EXTRACTS FOR THE ENVIRONMENT PROTECTION AUTHORITY

2. RESPONSES TO ISSUES RAISED ABOUT THE AMENDED PROJECT

Figure 2.4.3 Year 7 (2016 AQA) Source Locations Compared with Year 7.75 (2013 AQA) Source Locations

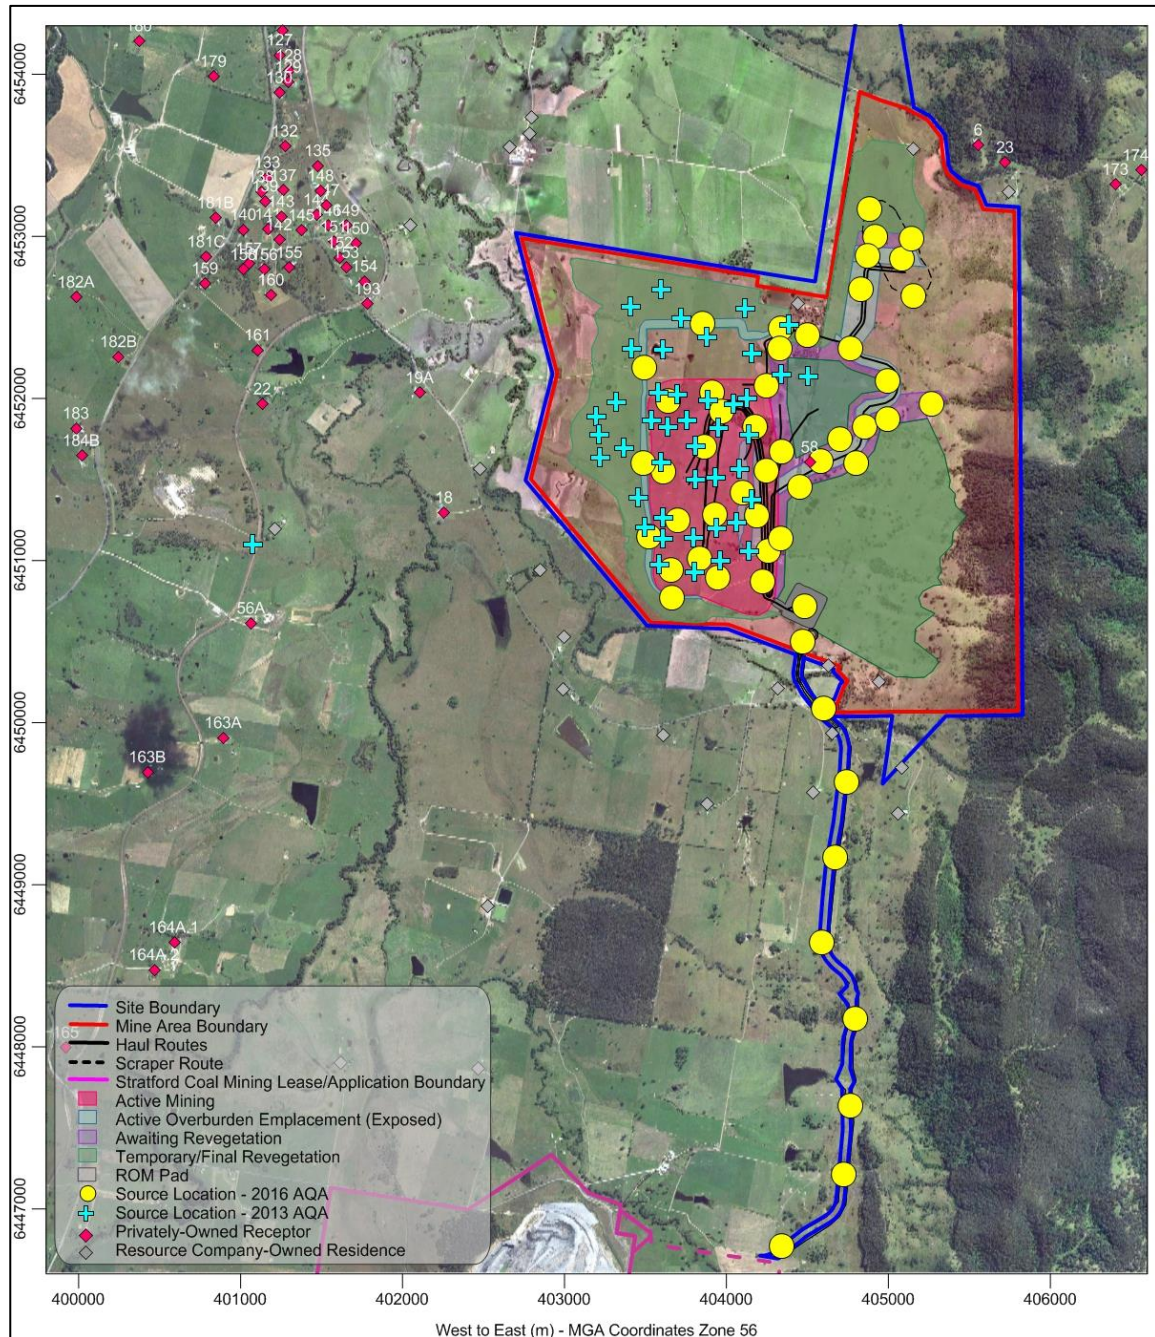
Estimated emissions from the amended project differ significantly from the original project with consequent changes to the assessed impact on sensitive receptors. Reduction in coal processing reduces emissions from this component of the processing.

Emissions estimation has been done to greater detail than in the original application. For both estimates, emissions of PM₁₀ and of PM_{2.5} are calculated as a fraction of estimated TSP. In the original application, a single value for each was used for all sources. Emission estimation for the amended proposal applies source-specific ratios. The resulting total emission estimate has lesser contributions from PM_{2.5} and PM₁₀ to TSP. The fraction of TSP that is PM₁₀ reduces from 0.39 to 0.29 and that of PM_{2.5} from 0.047 to 0.040.

The estimated total annual emissions for the amendment show PM₁₀ emissions are a smaller fraction of TSP emissions than in the original assessment. Emissions are also reduced as there is less coal handling and preparation.

It is therefore not possible to make a like-for-like comparison between the scenarios and outcomes of the two assessments as all of these changes will have influenced the predicted concentrations, not just total emissions.

The total TSP emissions are lower in the 2016 AQA in all years except for Year 7, which has a marginal increase in TSP when compared with Year 7.75 from the 2013 AQA. **Figure 2.4.3** shows the source locations used in the 2013 AQA for Year 7.75 compared with the source locations used in Year 7 of the 2016 AQA. It is apparent from this figure that the source locations in the 2013 AQA were closer to residences than those in the 2016 AQA. This alone explains the lower predicted concentrations for the amended Project compared with the 2013 Project.

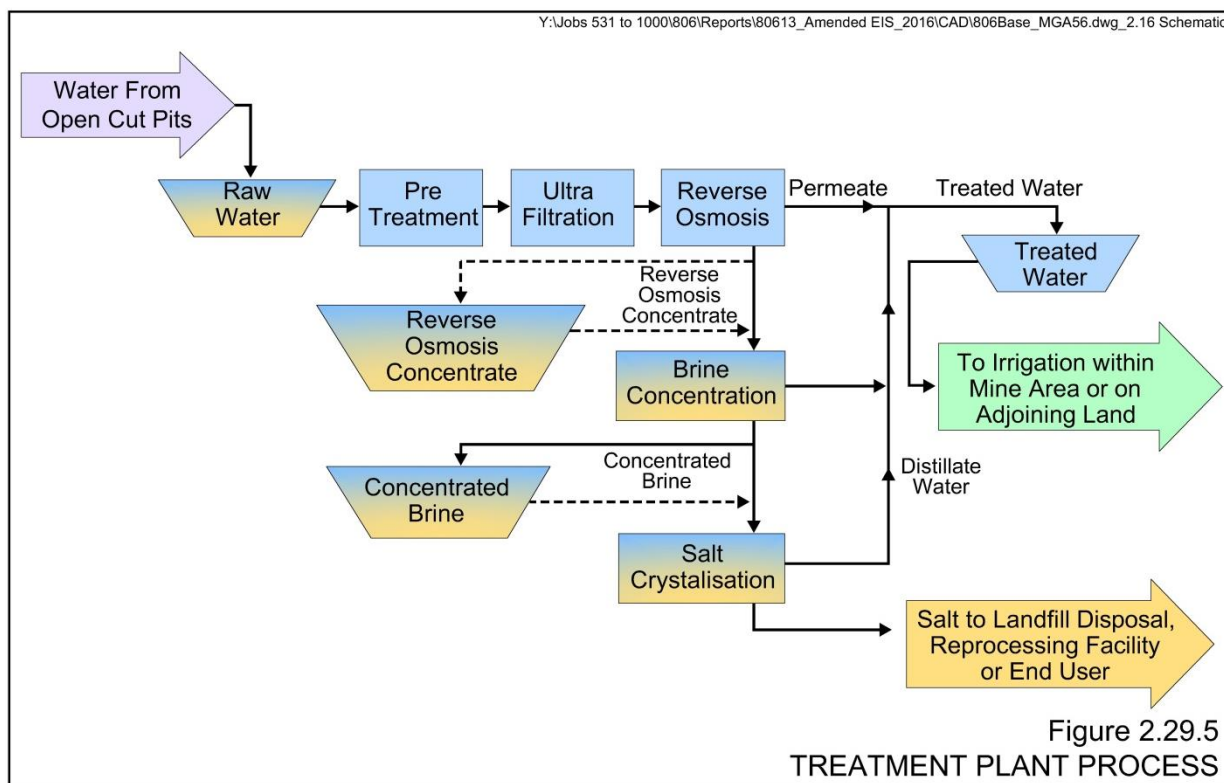
Salty minewater is proposed to be treated via a treatment plant (although not stated in the EIS it is expected by the EPA this will include a reverse osmosis treatment facility). Such a facility produces two products: a permeate with very much reduced salinity; and a concentrated (very salty) brine.

The proponent needs to be clear on the unit operations that are proposed in the water treatment plant so that the EPA can make an assessment of the potential risks involved.

RO is a proven process for the removal of dissolved solids from brackish or saline feed water and is particularly effective as it can treat water to a variety of qualities depending on the end use. It uses pressure to “force” water through a semi-permeable membrane, leaving the ions behind a clean water stream and a concentrated brine solution, which may be further treated.

As noted in EIS Figure 2.16 (reproduced as **Figure 2.29.5**), the likely system proposed to treat the excess water within the saline water zone and its subsequent brine waste, would likely involve the following steps, as further described below.
